SHORELINE CITY COUNCIL REGULAR MEETING

Monday, January 6, 2020
7:00 p.m.

AGENDA TITLE:	Adopting Ordinance No. 871 - Amending Certain Sections of the Shoreline Development Code to Provide for Townhouse Design Standards
DEPARTMENT:	Planning & Community Development
PRESENTED BY:	Catie Lee, AICP, Associate Planner Nora Gierloff, AICP, Planning Manager Rachael Markle, AICP, Director
ACTION:	<input checked="" type="checkbox"/> Ordinance <input type="checkbox"/> Resolution <input type="checkbox"/> Motion <input type="checkbox"/> Discussion <input type="checkbox"/> Public Hearing

SECTION A CLERICAL ERRORS AND ACCURATE ILLUSTRATIONS AMENDMENTS (Motion language at end of this Section)

Amended illustration and new illustration for 20.50.160(B)(1), uses term “Right-of-Way”:

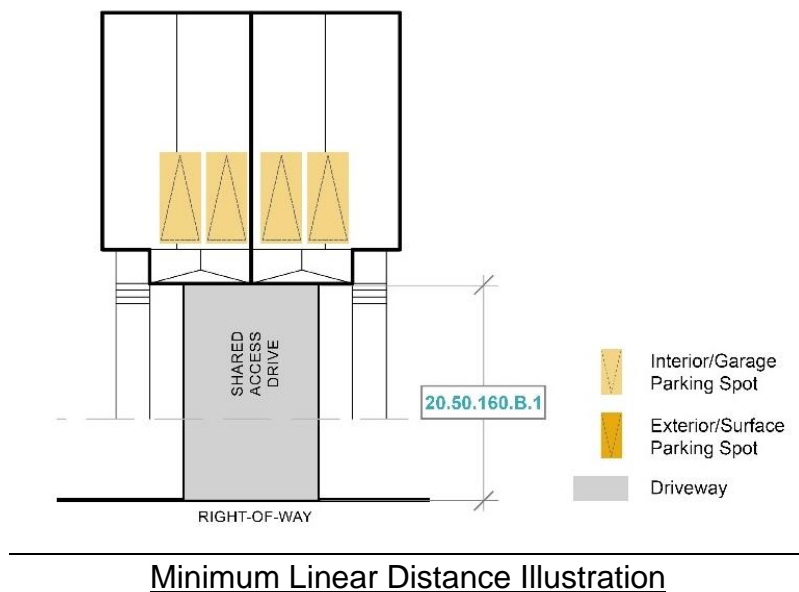
Justification: This illustration needs to be updated to change the words “Primary Street” to “Right-of-Way” for accuracy and consistency with the other illustrations. Planning Commission illustration for 20.50.160(B)(1), uses term “Primary Street”:

Planning Commission illustration for 20.50.160(D)(2):

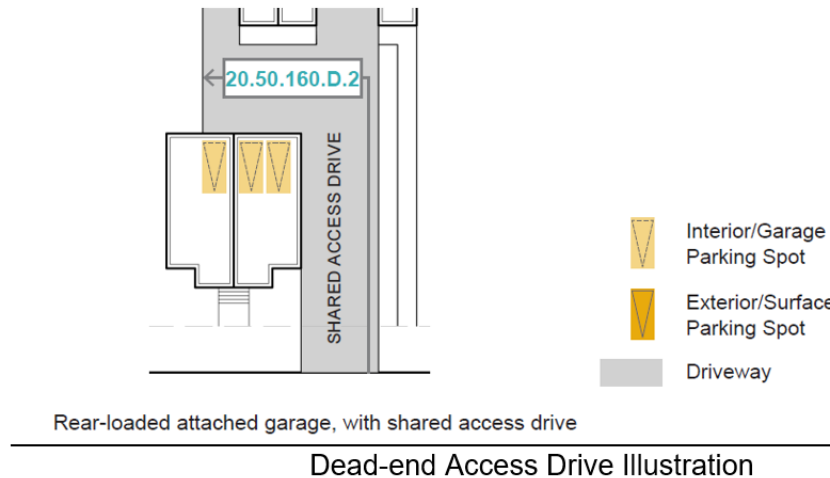
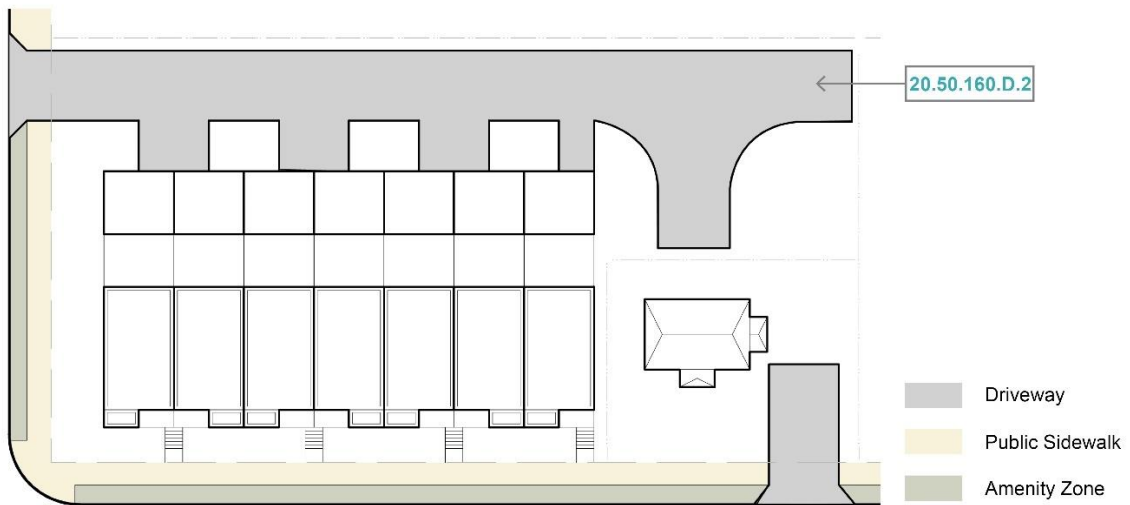
Justification: The Planning Commission illustration for a dead-end access drive is not clear in its depiction of the proposed code standard. The amended illustration clarifies that a turnaround facility is not needed in this instance since the measurement of the access drive from the curb to its furthest extent is less than 150 feet. A new illustration is proposed to show a scenario that requires a turnaround facility. In this example, the distance from the curb to the furthest extent of driveway without the turnaround facility is 170 feet. The turnaround facility depicted is based on a draft Standard Detail produced by the Public Works Department in the forthcoming update to the Engineering Development Manual (“EDM”) that will take place in March 2020. The EDM is a technical manual and the most appropriate document to provide such engineering details. The illustration shown here depicts the basic concept but for the actual specifications the designer needs to reference the EDM.

Dead-end Access Drive Illustration 1: Access drive is less than 150 feet, so a turnaround facility is not required

Planning Commission illustration for 20.50.160(D)(3):

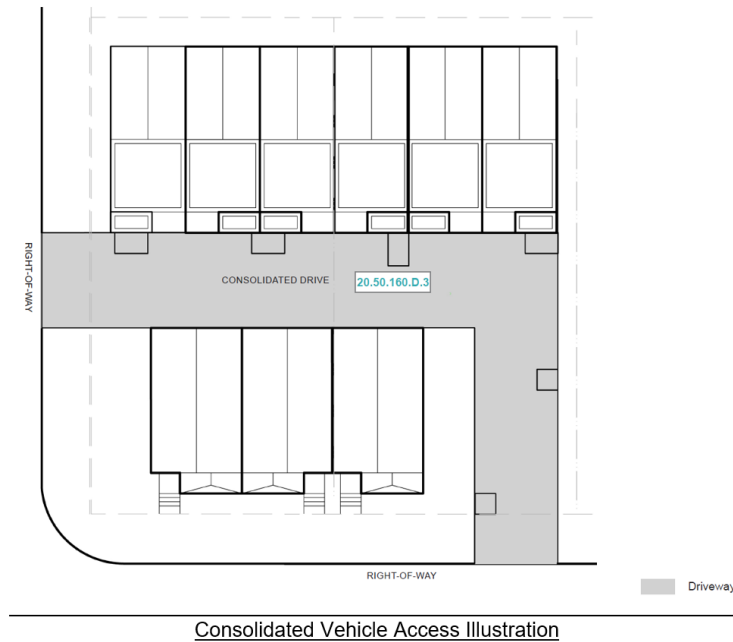
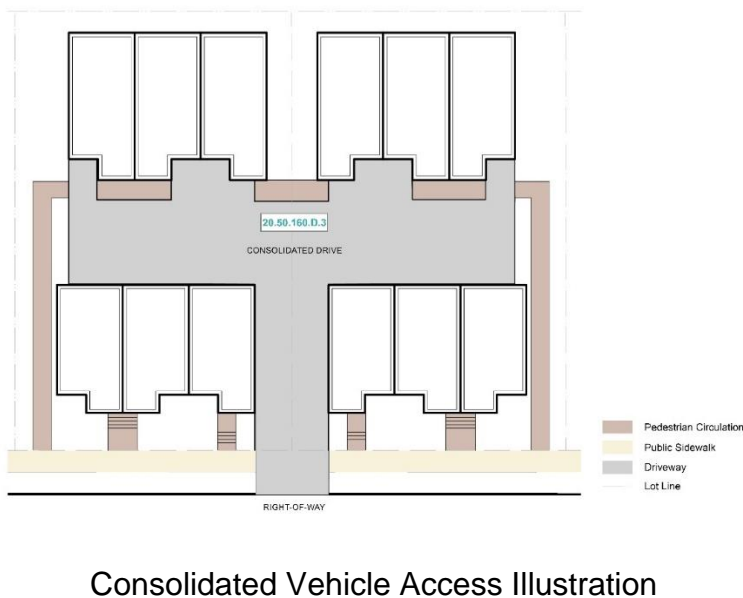
Justification: The Planning Commission illustration for consolidated vehicle access is not a good example of the proposed code standard. In the configuration shown, the City would require a lot merger since proposed structures straddle an existing lot line.

The amended illustration is an accurate depiction of the proposed code standard: two separate lots, being developed concurrently, are exempt from the side yard landscaping requirement if they share an access drive. In every other regard, such as compliance with dimensional standards such as setbacks and the rest of the design standards, each site shall comply individually with code standards.

Planning Commission illustrations for 20.50.160(D)(4) and (5):

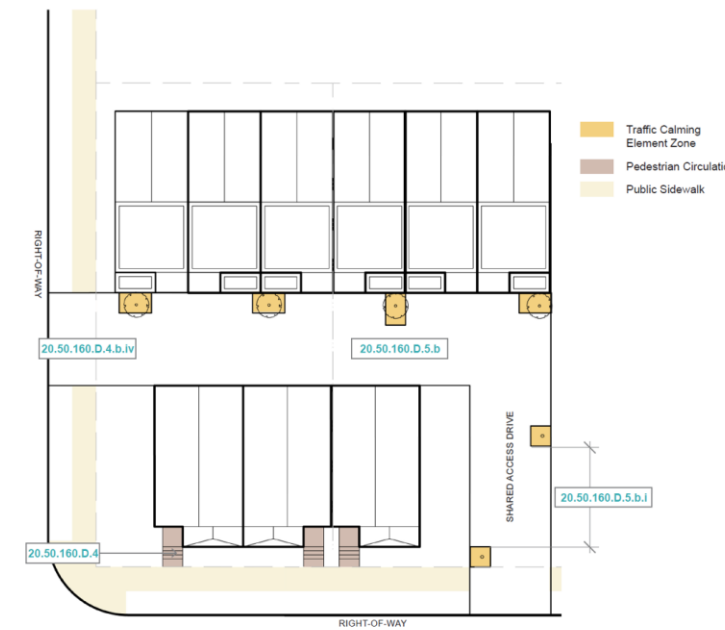
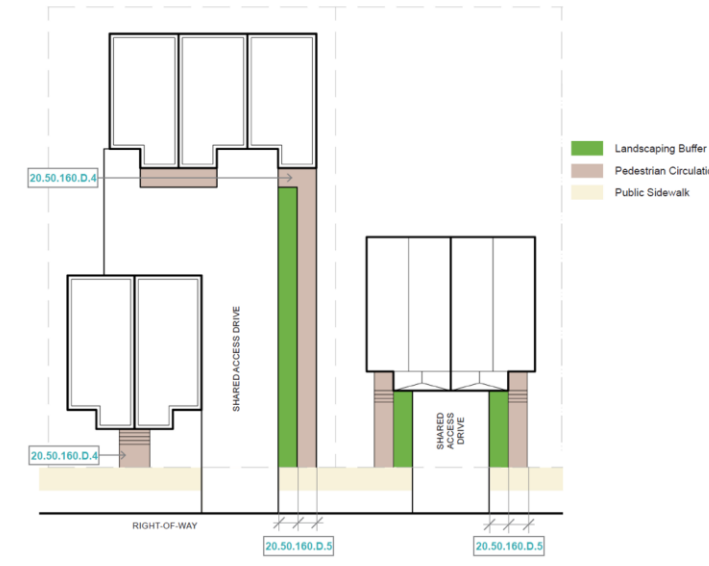
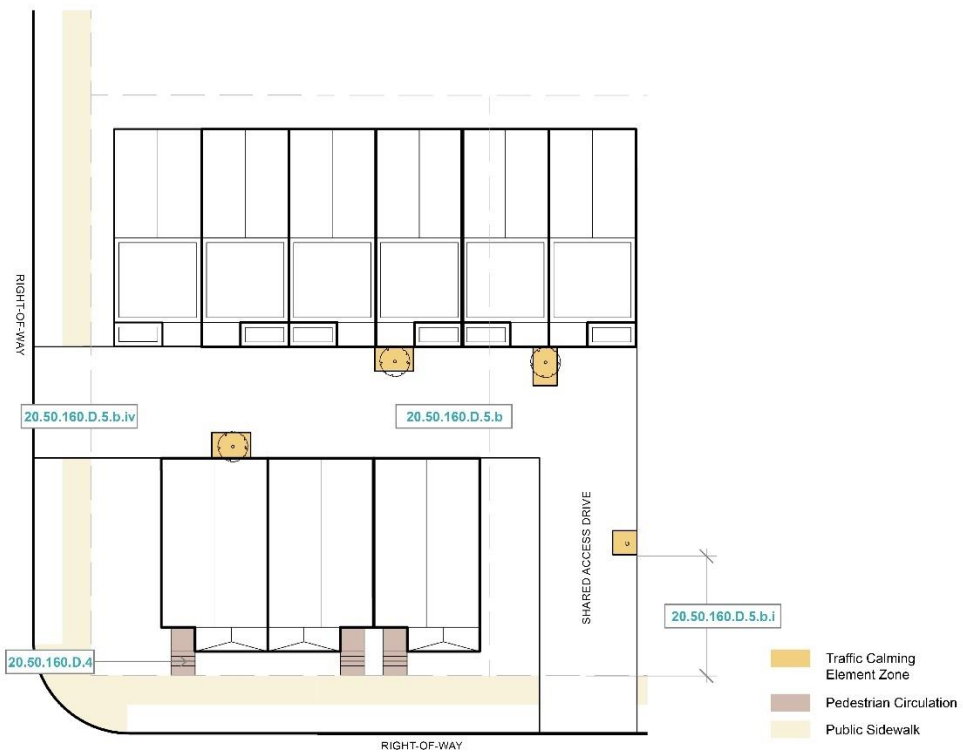
Justification: The second illustration from the Planning Commission recommended code for site access and circulation shows a planter box or bollard immediately as a vehicle would turn onto the site. The amended second illustration removes this element to allow for turning onto the site. The only change to the first illustration is placement of the legend.

Planning Commission illustrations for 20.50.160(G):

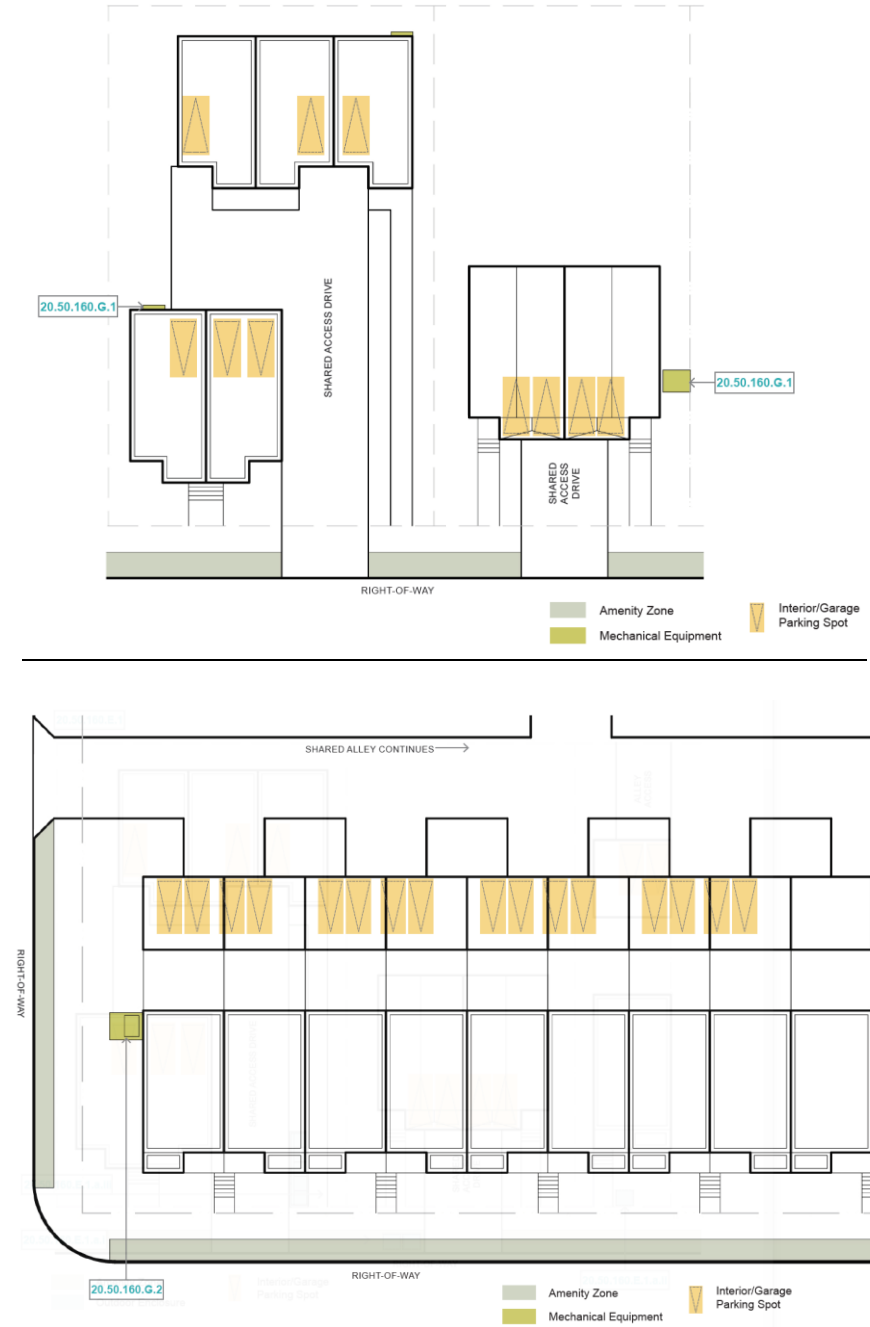
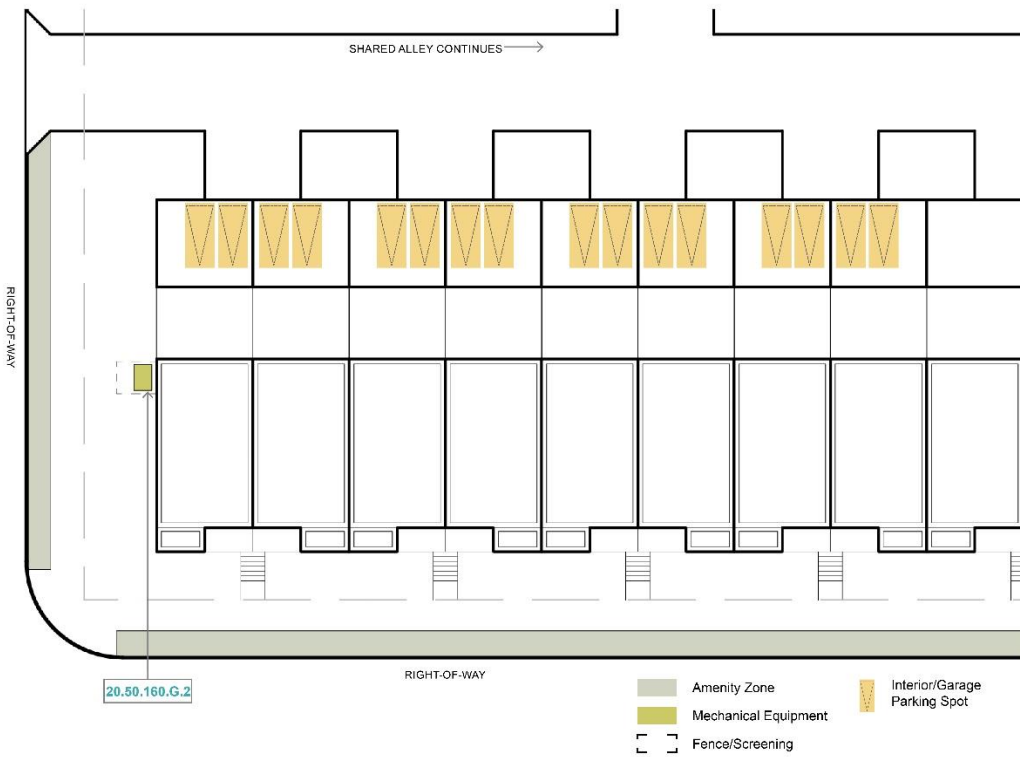
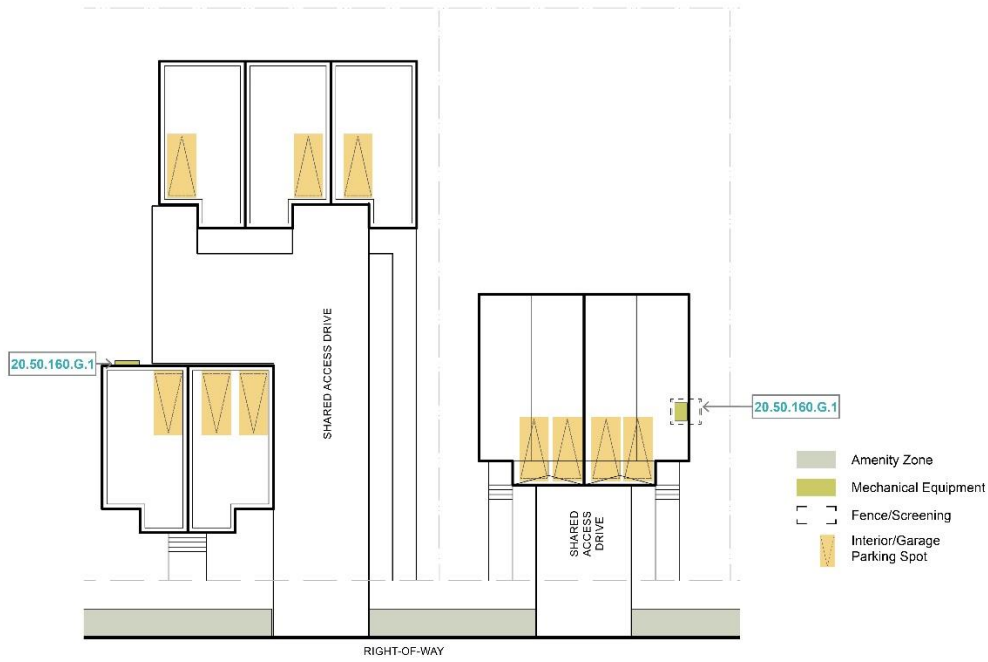
Justification: The first illustration from the Planning Commission illustrations for utility and mechanical equipment shows mechanical equipment projecting into a five-foot setback larger than the size allowed by code. The second illustration from the Planning Commission illustrations for utility and mechanical equipment is not clear that screening is provided. The amended first illustration shows code compliant mechanical equipment that is out of the setback and is screened. The amended second illustration contains screening that is called out in the legend.

Planning Commission illustration for 20.50.160(H):

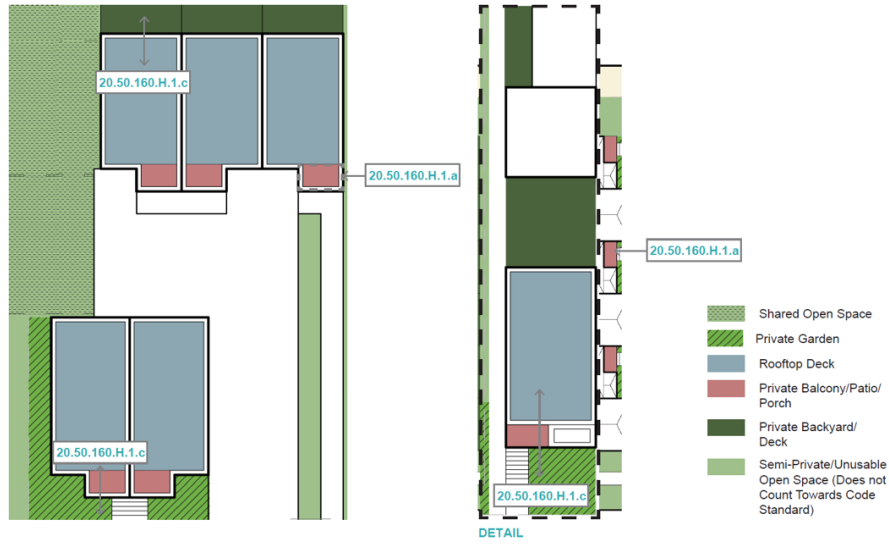
Justification: The Planning Commission illustrations contain inaccurate references to “20.50.160.H.1.c” which does not exist. The amended illustrations contain the correct reference to “20.50.H.1.a” and “20.50.H.1.a.iii.”

Building Modulation, Massing and Articulation Illustration 1

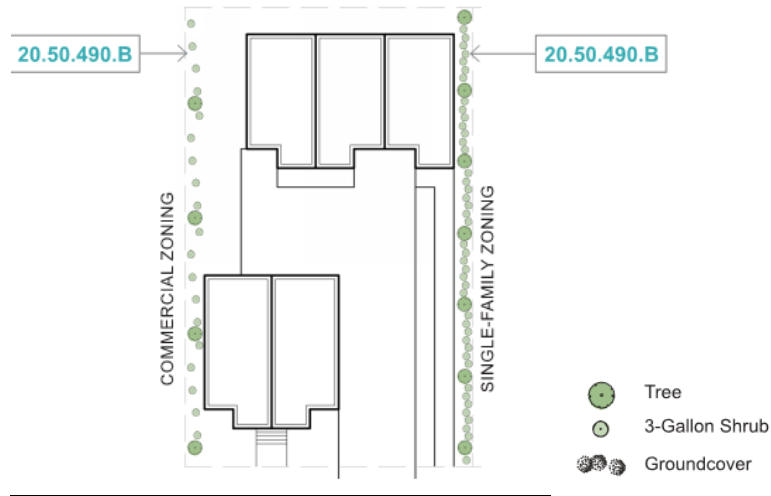
Justification: The Planning Commission illustration omitted the landscaping symbol from the legend. The amended illustration includes the landscaping symbol on the legend.

Amendment Proposer: Councilmember Roberts

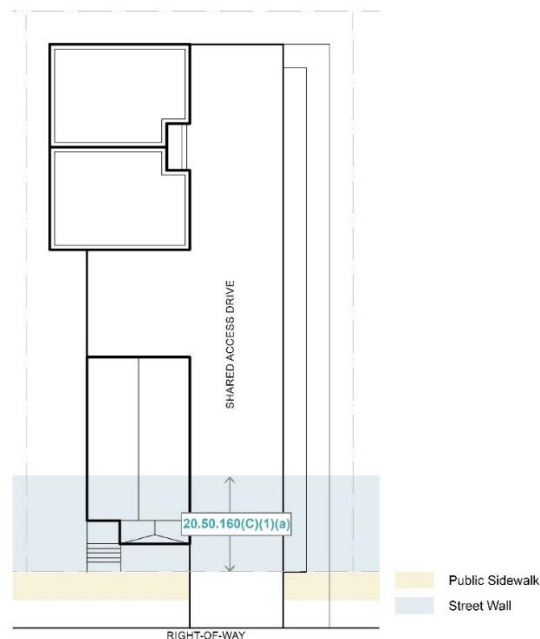
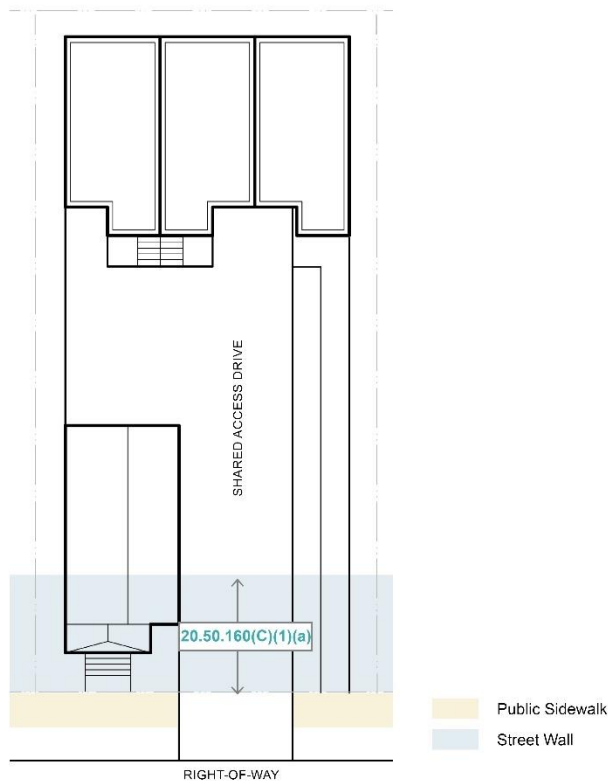
Justification: Reducing the proposed requirement from 30% to 25% of units in all zoning districts except MUR-45' that have to be within 25 feet of the front property line on lots up to 70 feet wide allows more units to be built on the site, although they will be skinnier. Note that in the 25% illustration provided, which depicts one detached unit in front and four units tucked behind, the front unit is 22 feet wide and the rear units are 16 feet wide. This is in contrast with the 30% illustration in which all units are 22 feet wide. More units are beneficial in achieving the purpose of higher density development in the MUR-35' zoning district but could also lead to undesirable outcomes such as the perpendicular-orientated, linear configuration development. This configuration is not shown in the illustration but is still feasible with a requirement of 25%.

a. On lots up to 70 feet in width, at least ~~30~~ 25 percent of units within a site shall be located between the front property line and a 25-foot distance from the property line.
